**THE NETWORK RAIL (OLD OAK COMMON GREAT WESTERN MAINLINE TRACK ACCESS) ORDER**

**REBUTTAL EVIDENCE OF Chris Ford**

**3 NOVEMBER 2023**

Project / Contract	OOC	
Location / Sub-location	OOC / GWML Station	
Title	16.6m Trailer swept path (South) Old Oak Common Lane to IEP Depot Pedestrian Footway retained

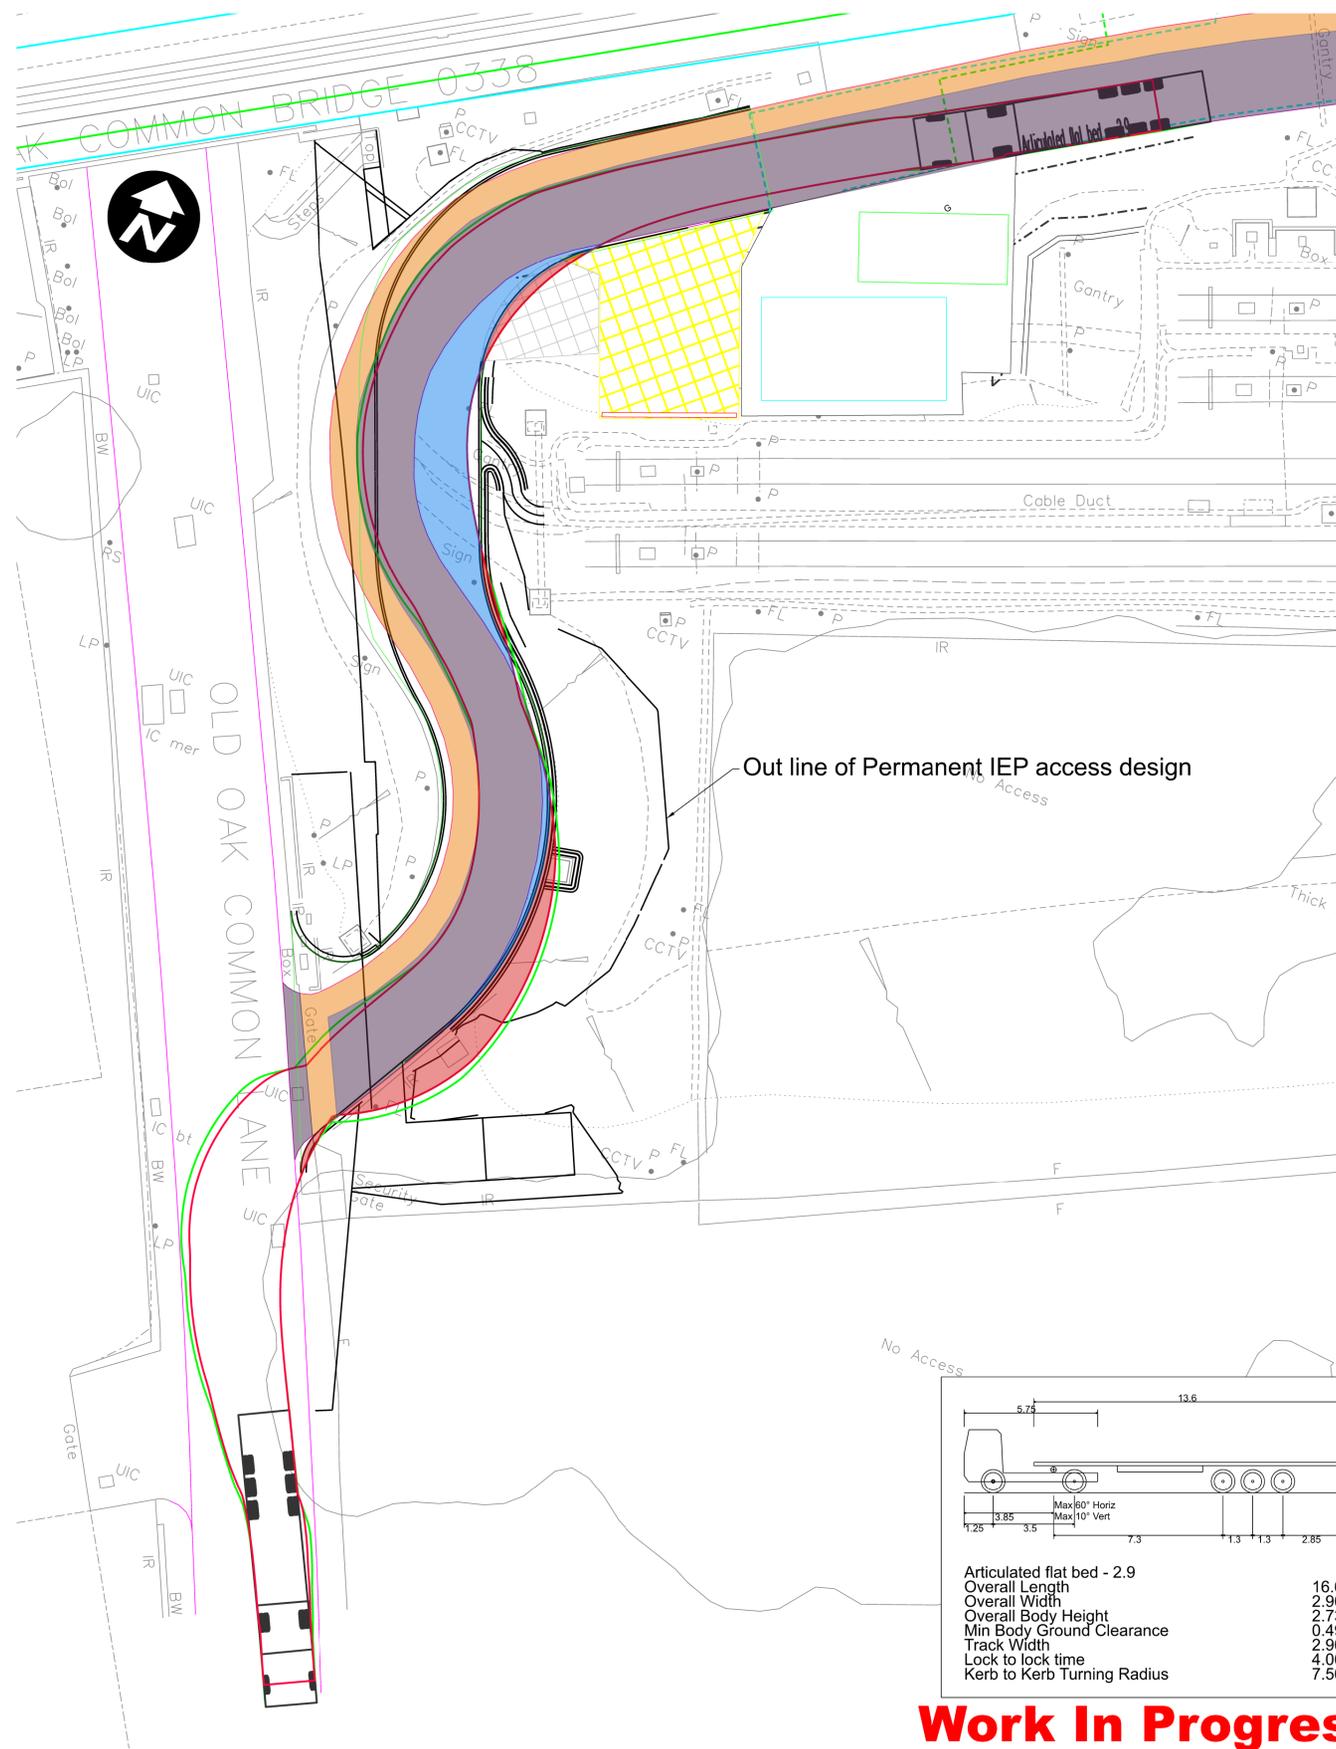
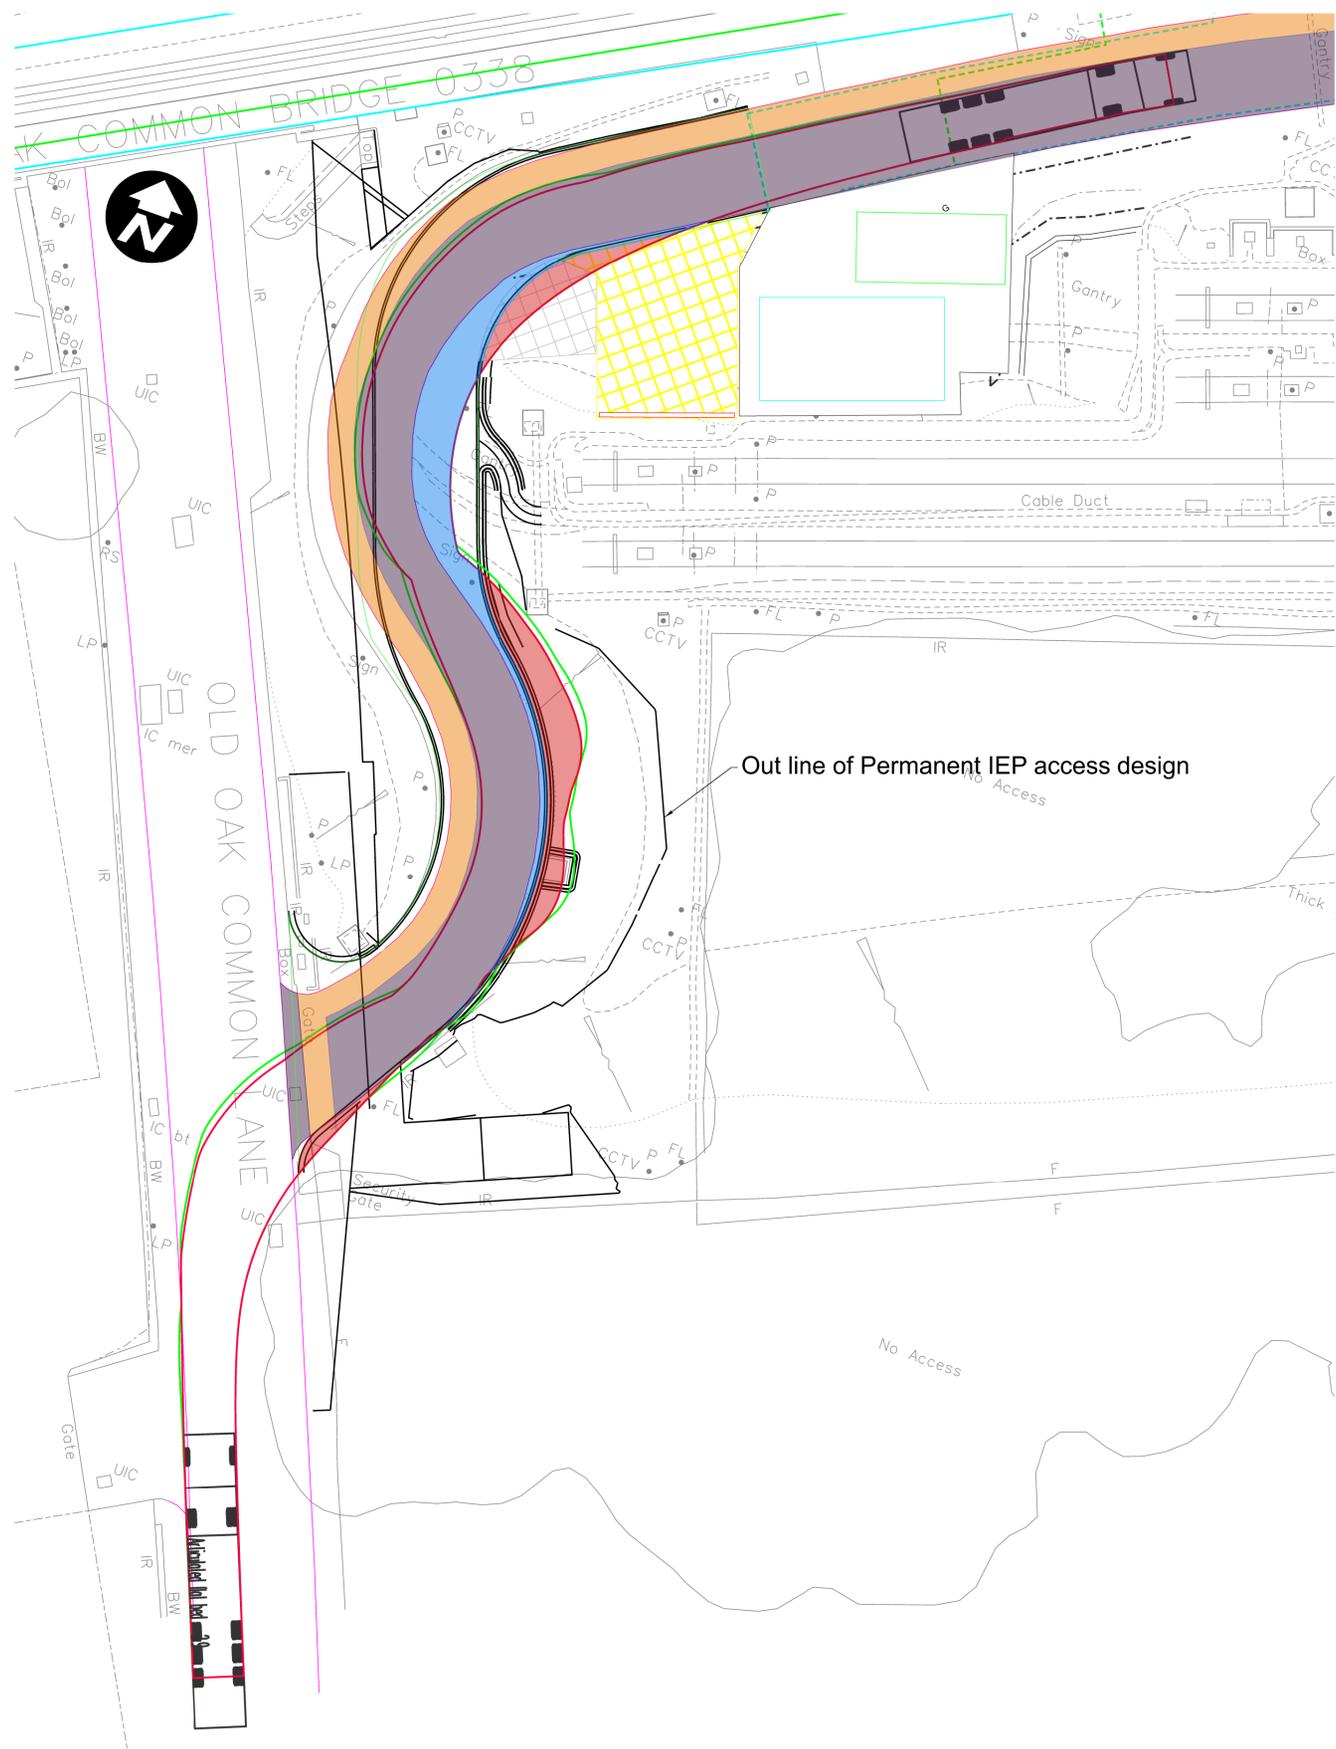
<p>Mr Douch provides an extensive rebuttal to the highways matters relevant to use of the Old Oak Common Lane access into North Pole Depot in his rebuttal evidence.</p> <p>Swept path analysis of this road undertaken by BBVS has identified that the required vehicles would not fit up the access from Old Oak Common Lane without alteration. Although the alteration may be feasible, there is further complexity due to the construction sequence in this area which makes it unsuitable for a temporary access route. Old Oak Common Lane is lowered in two phases to support the HS2 works in the area. Due to this lowering, a reconstruction of this access road is required. To the best of my knowledge this is due to take place mid-2025 to mid-2026. During this period (6-month window) there would be no access due to re-construction activities. As such it would not be usable and therefore unable to support the GWML Rail Systems programme as a suitable alternative. Further evidence is provided in section 6.1 of my proof of evidence.</p> <p>In addition it should be noted that HGV moves are limited to 12 HGVs per day when related to HS2 works south of Old Oak Common Lane. The number of HGVs required to access the RRAP compound, as identified in the transport statement, is within this restriction any movements required on behalf of HS2 (via BBVS) pose a risk of exceeding the 12 HGVs per day and breaking this limit. although acknowledging that the transport statement shows that this is an acceptable limitation. This route along this stretch of Old Oak Common Lane to the A40 passes through a predominantly residential area. It should also be noted that this road is on a bus route for the 228 bus, frequency 20-30 minutes between 0500 and 0130 daily.</p> <p>In addition, the site access road has a downward gradient as it approaches Old Oak Common Lane, which itself also has a downward gradient, and therefore affects speed and braking of approaching traffic</p>
